7 April 2025

PUBLIC CONSULTATION, CASEY FIELDS SOUTH EMPLOYMENT + DEVON MEADOWS PRECINCT STRUCTURE PLAN (PSP)

Figure 1 Proposed PAO in black; affected landowner in yellow.

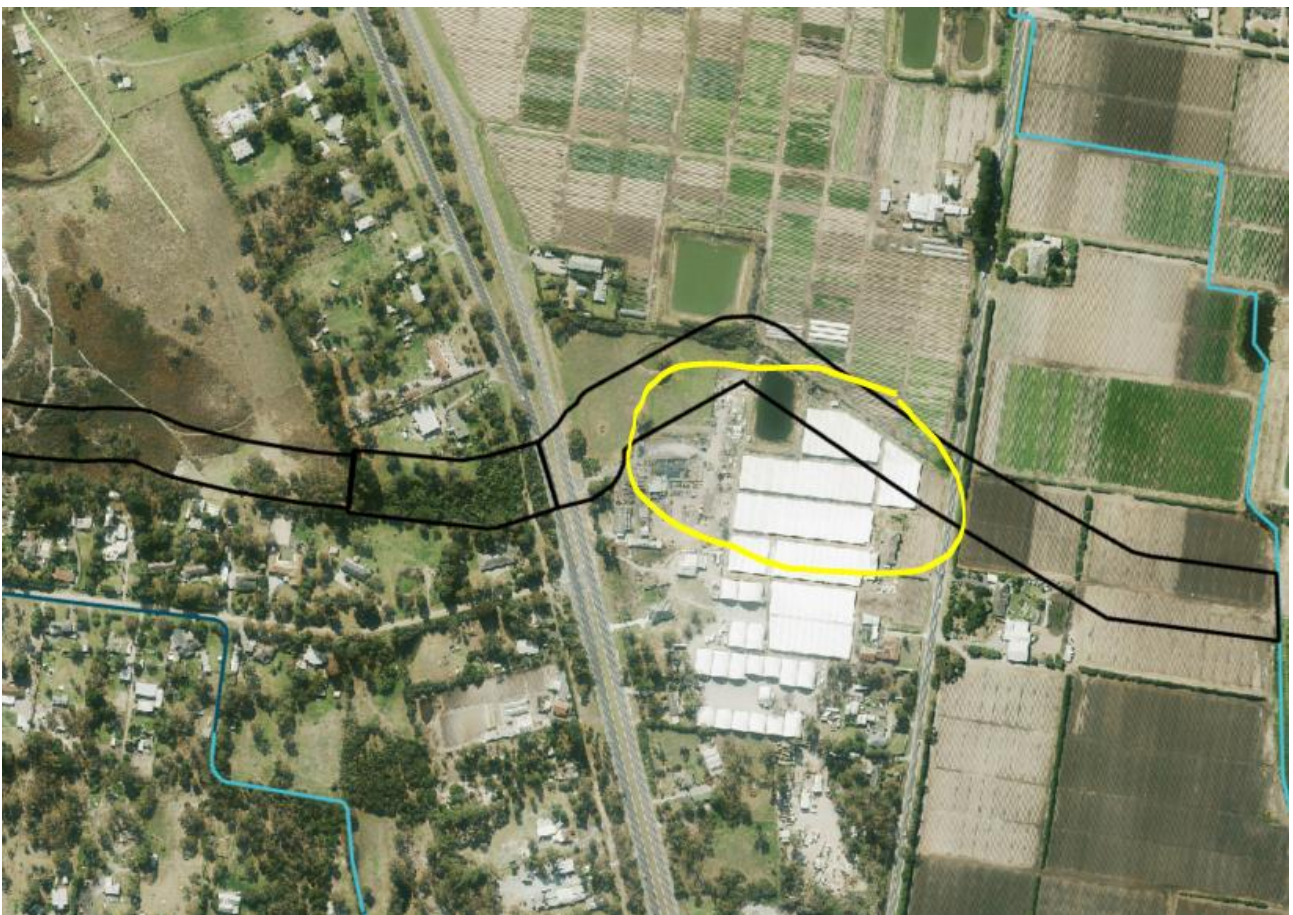
We advise further that, as an example, the VPA and Melbourne Water commence targeted consultation with key landowners affected by the PAO (the landowner circled in yellow in Figure 1). This landowner has an existing use/business that will be impacted by the PAO. Their existing use may delay the delivery of the asset.

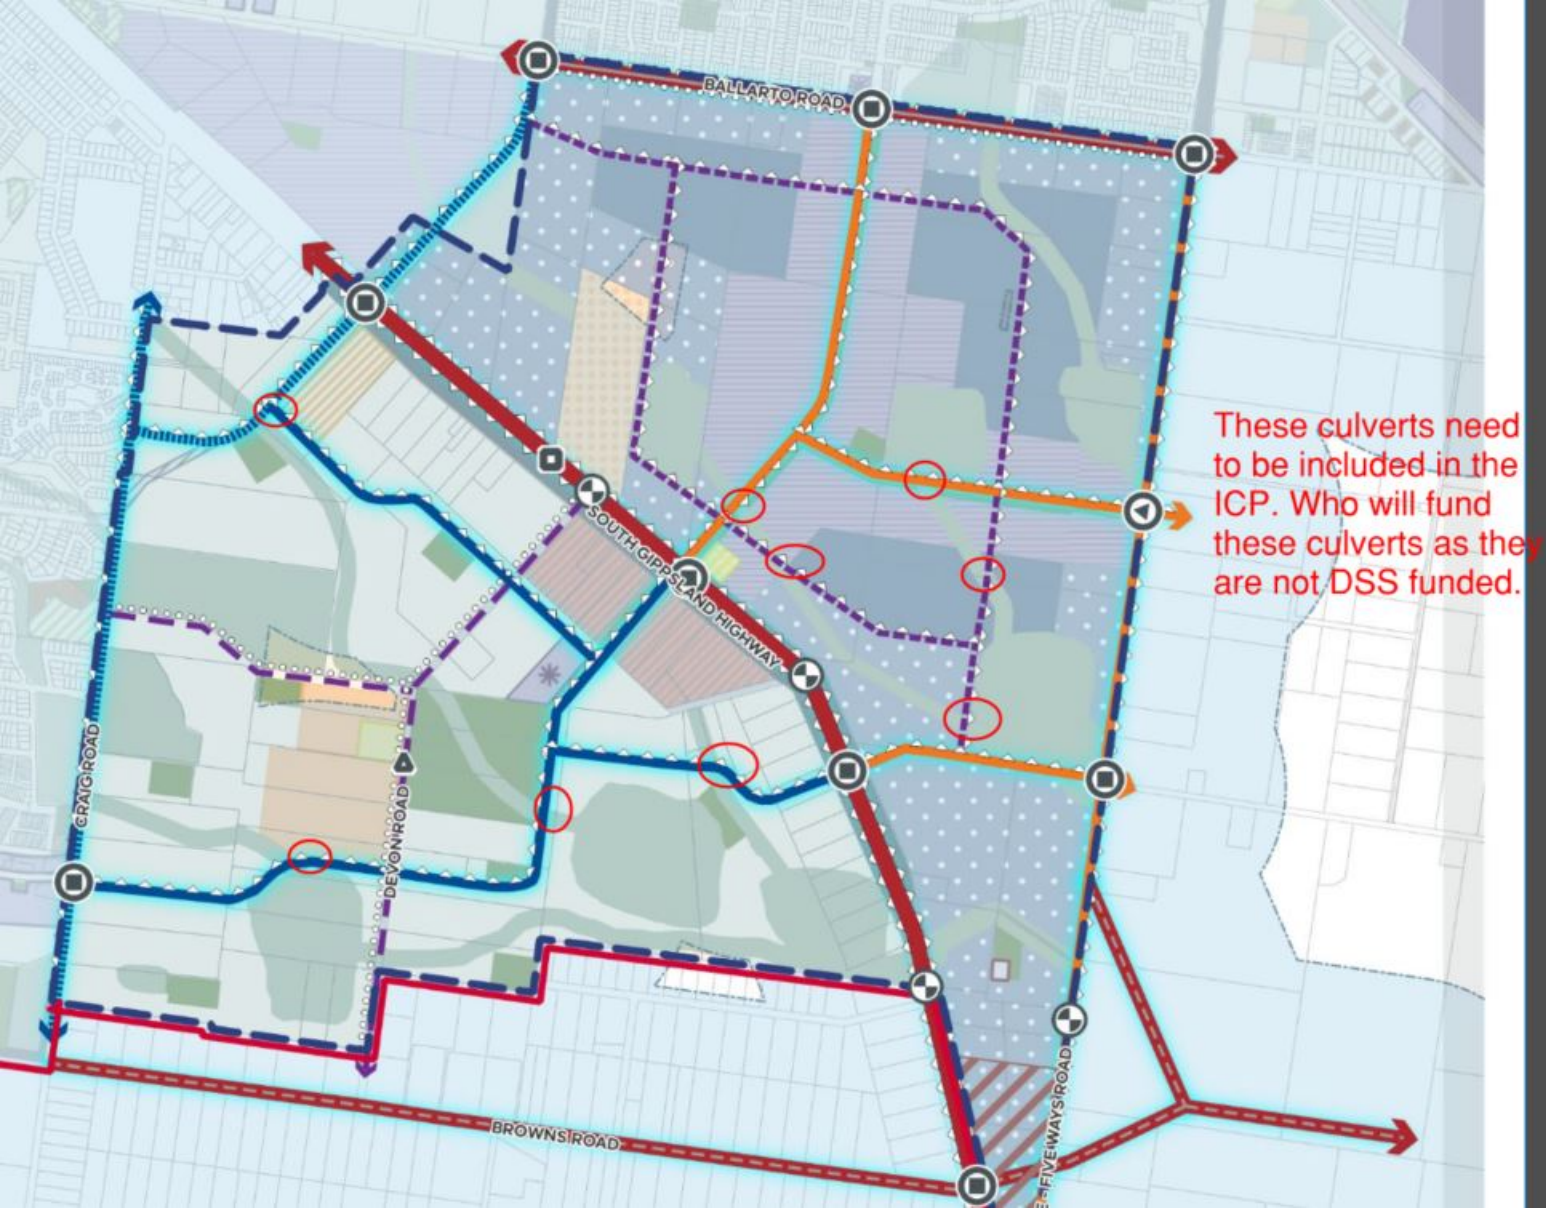
4	PSP document	All plans	All plans	Fix	There is a missing gap between one of the drainage RBs and the diversion channel. There needs to be a connected outfall here shown on all plans. MW to provide updated GIS. Refer to Fig 1	Fig 1: I:\MEL\Development Strategies\Drainage Schemes\2000's\2362 - Devon Meadows DS\Implementation\PSP Project GHD\9-
5	PSP document	R3	Safe, accessible	Add new	Add new statement in R3: "Crossings of waterways must be delivered where shown on Plan 4 Movement Network and must be designed to ensure that flood flows can still be conveyed by the waterway or the overland flow path, to the satisfaction of Melbourne Water"	
6	PSP document	Plan 4	Funding	Add new	New culverts crossing waterways are to be added on the plan (circled in red). These culverts are not DSS funded - VPA to determine the funding mechanism. Refer to Fig 2	Fig 2: I:\MEL\Development Strategies\Drainage Schemes\2000's\2362 - Devon Meadows DS\Implementation\PSP Project GHD\9-

Fig 3:

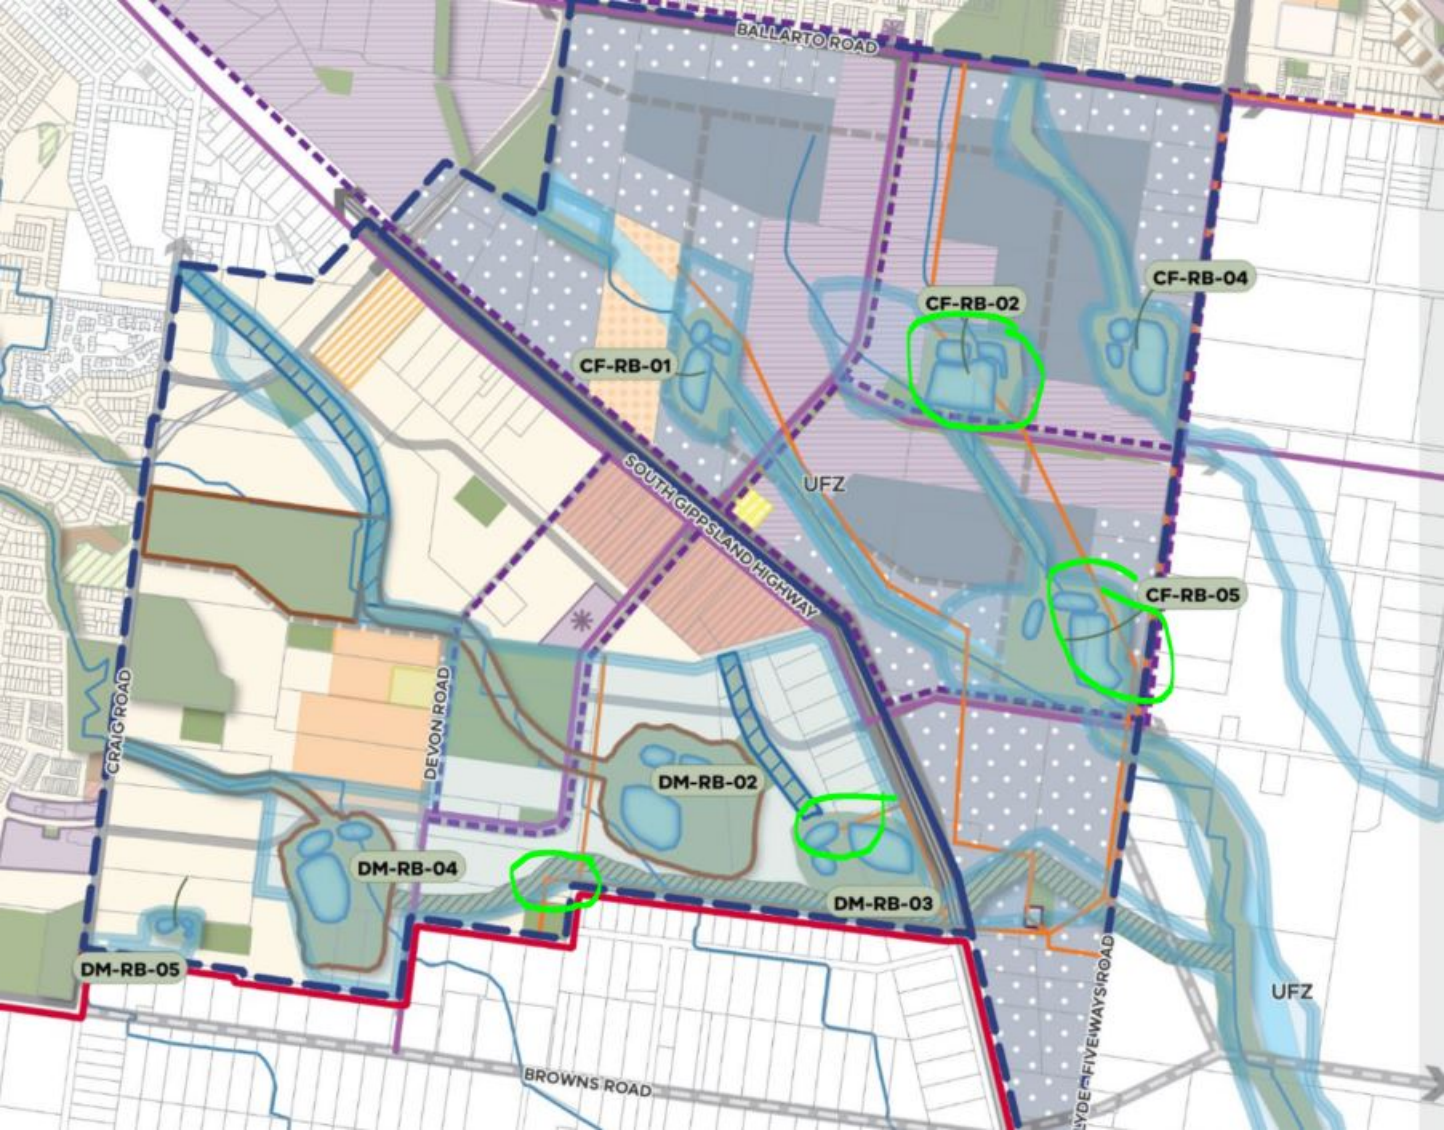
O2 and O3 to be removed, as access issues will be problematic in ensuring the ultimate is delivered.
